Access Compliance Report Public Rights-of-Way (Curb Ramps)

Main Street: **EARLYWOOD** Cross Street: **DAWNWOOD** Location: **SW**

ADA ID: **RPRK211025120925** Ramp Type: **Type 4 - Parallel** Initial Pass/Fail: **Fail** Overall Compliance: **No** Severity Score: **2**

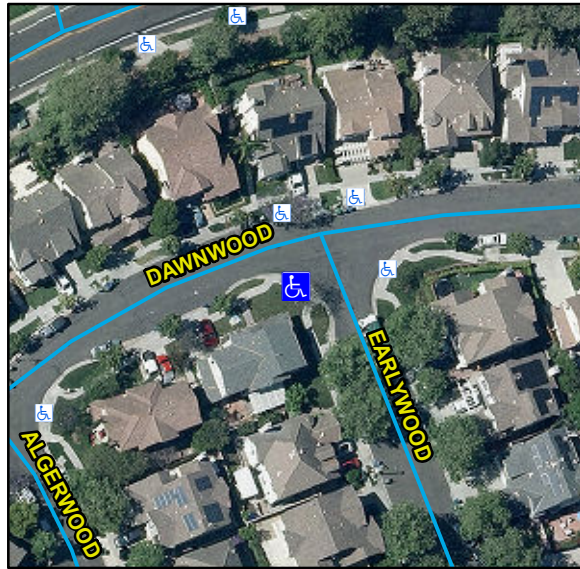
R204.3, R304.5.3, STD 1115

Compliance	Description	Data	Compliance	Description	Data
N/A	Ramp Length LT (in)	109	N/A	Ramp Length RT (in)	116
Yes	Ramp Width LT (in)	48	Yes	Ramp Width RT (in)	48
Yes	Ramp Run Slope LT (%)	7.5	Yes	Ramp Run Slope RT (%)	6.7
No	Ramp Cross Slope LT (%)	3.5	Yes	Ramp Cross Slope RT (%)	1.9
N/A	Landing Present	N/A	N/A	DWS Provided	N/A
N/A	Landing Length (in)	N/A	N/A	DWS Contrast	N/A
N/A	Landing Width (in)	N/A	N/A	DWS Length (in)	N/A
N/A	Landing Run Slope (%)	N/A	N/A	DWS Full Width	N/A
N/A	Landing Cross Slope (%)	N/A		DWS Offset Type	N/A
N/A	Landing Movement Obstructed?	N/A	N/A	DWS Offset Left (in)	N/A
	Landing Movement Type	N/A	N/A	DWS Offset Right (in)	N/A
N/A	Landing Shared	N/A			
N/A	Clear Space	Yes			
N/A	Clear Space To Crosswalk (in)	N/A			
N/A	Marked Crosswalk 1	No	N/A	Marked Crosswalk 2	No
	Crossing 1 Direction	E		Crossing 2 Direction	N
	Marked Crosswalk 1 Width (in)	N/A		Marked Crosswalk 2 Width (in)	N/A

Remove & Replace Curb Ramp With Two New Directional Ramps or Equivalent.
